DRAWING AMENDMENTS

Two replacement figures are proposed in the instant Office Action response. First, a new Fig. 20 is proposed. During a telephone interview with Examiner Green, the applicants determined that the valley trusses in the original Fig. 20 were inconsistently identified and also realized that the positioning of multiple present invention devices in Fig. 20 made them difficult to view. As a result, one of the applicants has redrawn Fig. 20 with a clarified identification of the valley trusses therein and the needed positioning of the present invention device relative to each valley truss. The applicants believe that no new matter has been added by the changes made to Fig. 20. Further, since the new Fig. 20 more accurately identifies the usable position of the present invention relative to each valley truss used, the applicants believe that the original Fig. 21 no longer adds any new information about valley trusses or the present invention. Thus, since the old Fig. 21 has become merely duplicative, the applicants propose that the original Fig. 21 be deleted. In addition, the applicants provide herein a new illustration intended to replace the Fig. 22 they proposed in t

Fig 21

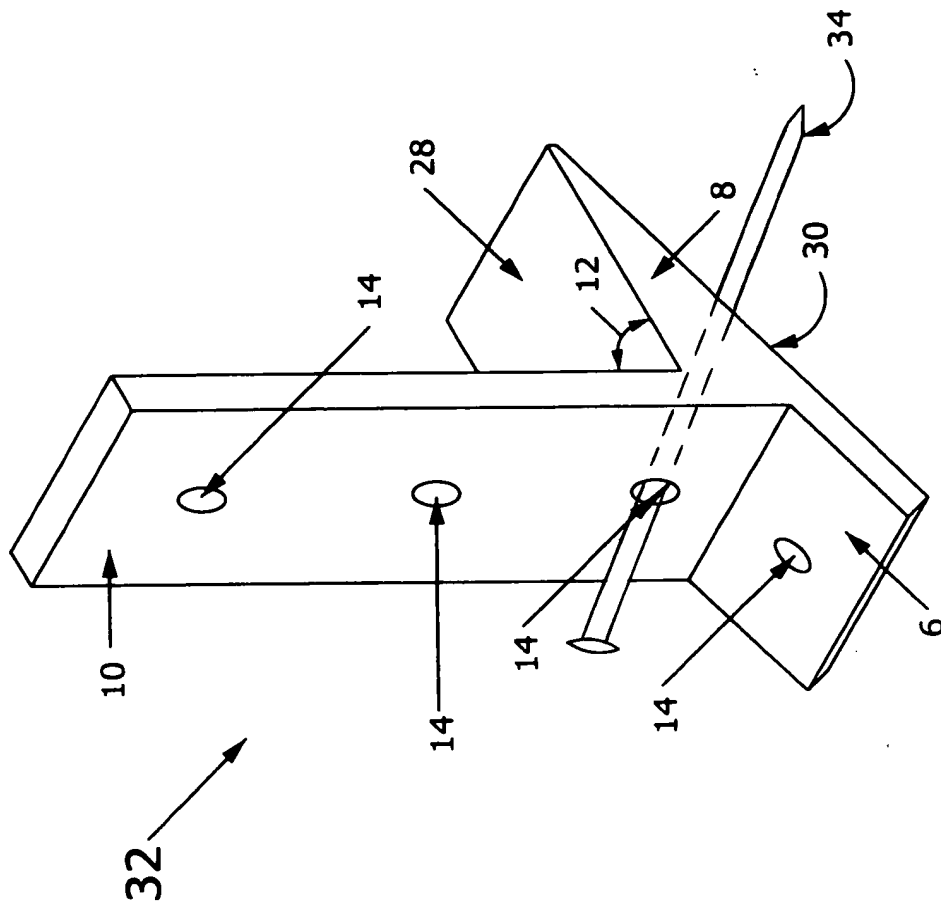
applicants believe that no new matter has been added thereby since page 17, lines 6-10 of the original disclosure discuss a molded embodiment. The applicants argue that the Examiner should allow this 'new' Fig. 21 to be a part of their allowed disclosure, as it is the finished shape of their valley truss strap and the manner in which it is used that are novel, irrespective of the method used to create that shape. Further, 'new' Fig. 21 is consistent with the elected Group 4 wherein the base member does not extend beyond the tapered end of the wedge. Other U.S. Patents, such as U.S. Patent 4,455,791 to Elko (1984), which in the discussion of its Fig. 4 discloses that its gutter's cover can be preformed out of plastic or metal, as well as U.S. Patent 6,516,498 to La Coy (2003) for a clamp that discloses manufacture out of plastic or metal, support the applicant's argument that different materials, to include plastics and flat steel, can be contemplated as alternative options for the construction of the embodiments in a single patentable invention. Therefore, the applicants respectfully argue that the Examiner herein should follow precedent and allow proposed 'new' Fig. 21 to become a part of the instant patent application disclosure. Thus, the applicants request reconsideration and clarification by the Examiner on this issue.
